LOOK TRAILER AXLE HANGER BRACKET

Recall Number:	19V-619		
Product:	Trailer Axle Hanger Bracket	Labor	0.5 Hour (inspection per trailer)
Date:	August 22, 2019	Rate:	2.0 Hours (procedure per axle)

Fig. 1

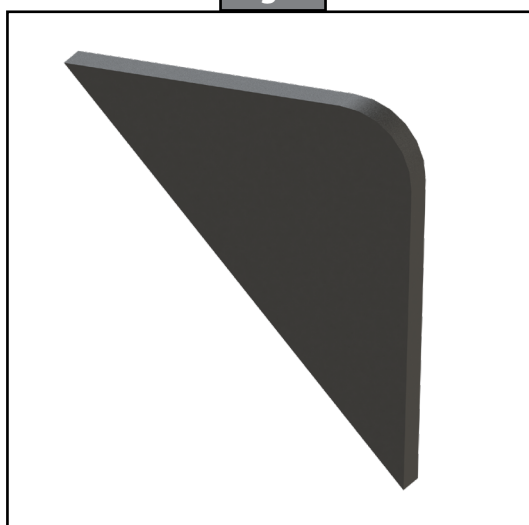
The intent of this document is to describe an inspection of the axles of the models listed to determine if the axle hanger brackets have the correct reinforcements. If a hanger bracket does require reinforcement, an aluminum gusset (Fig. 1) will be welded on both ends of the bracket.

Fig. 2

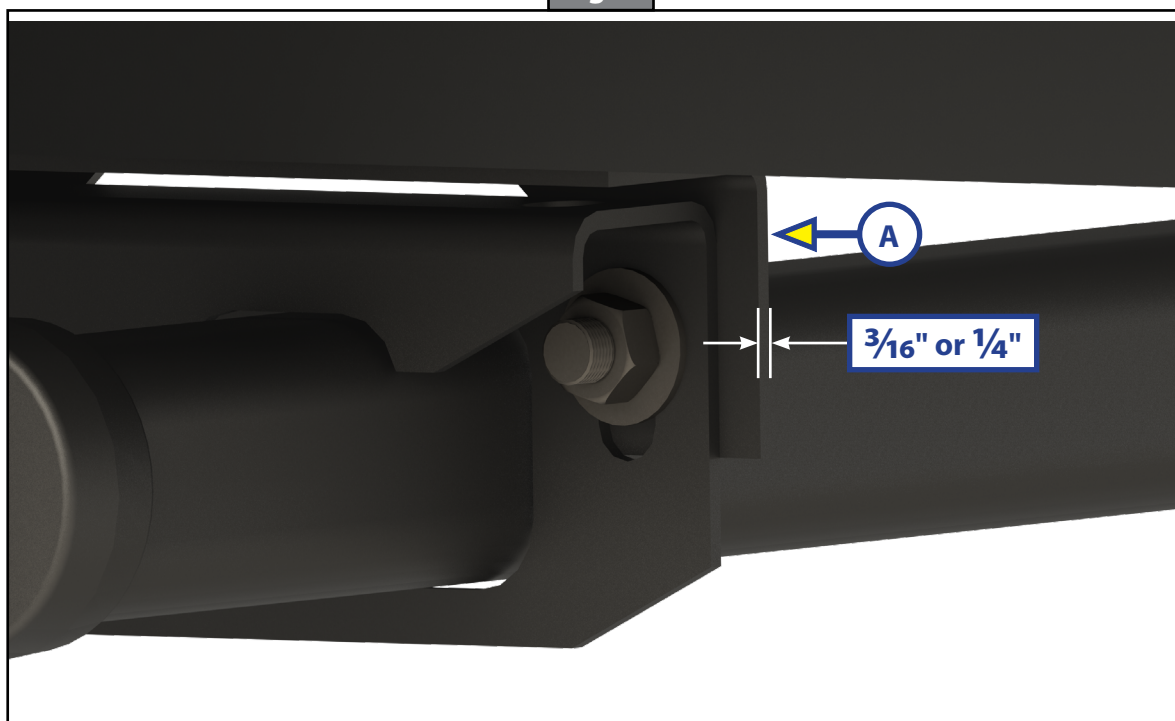
Measure the thickness of each aluminum side mount at Fig. 2A. If the mount measures $\frac{3}{16}$ ", then gussets will need to be added. A mount that measures $\frac{1}{4}$ " is the revised version and no action is necessary.

Fig. 3

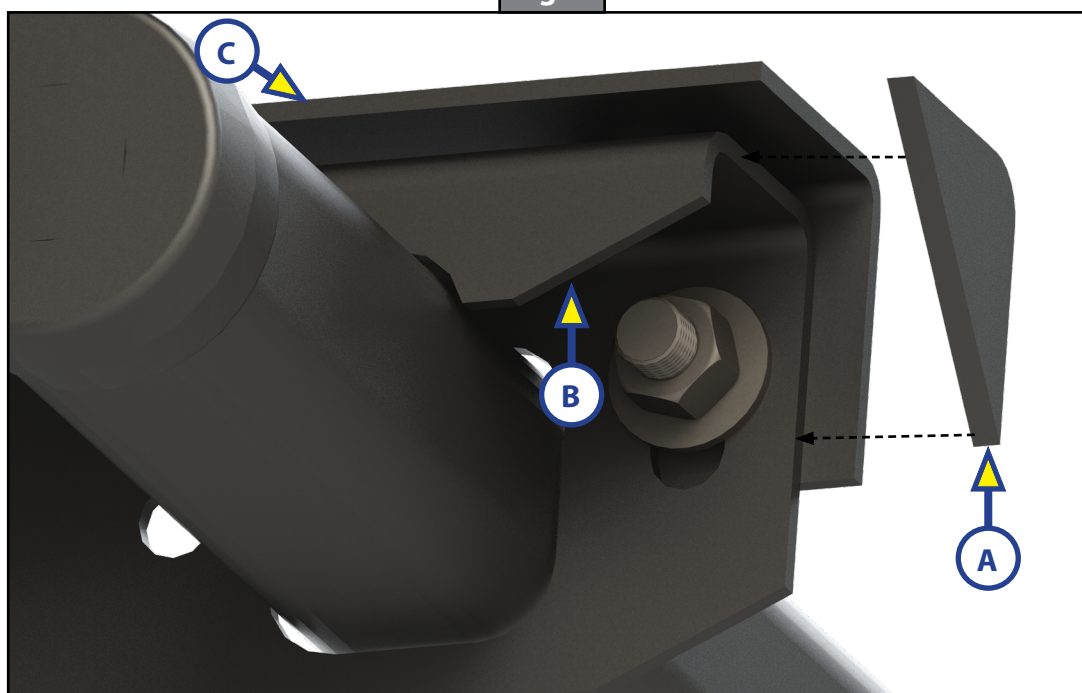
1. Push gusset (Fig. 3A) right up to the side of the torsion bracket (Fig. 3B) and against the inside edges of the aluminum side mount (Fig. 3C).

Fig. 4

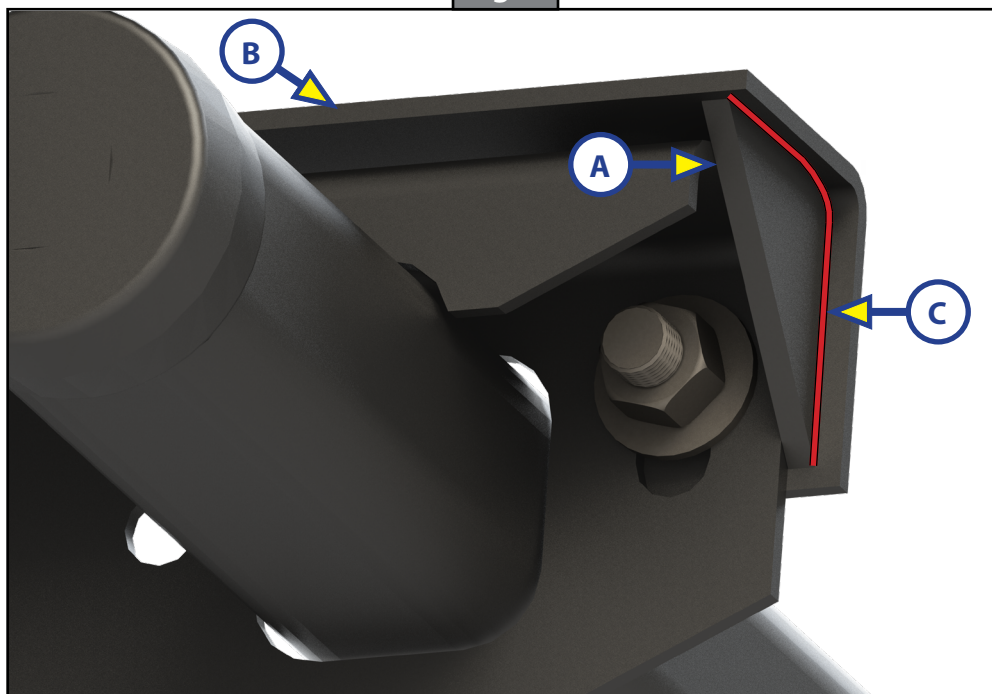
2. Fully weld the outside of the gusset (Fig. 4A) to the inside of the aluminum side mount (Fig. 4B) where indicated by the RED/BLACK line (Fig. 4C).
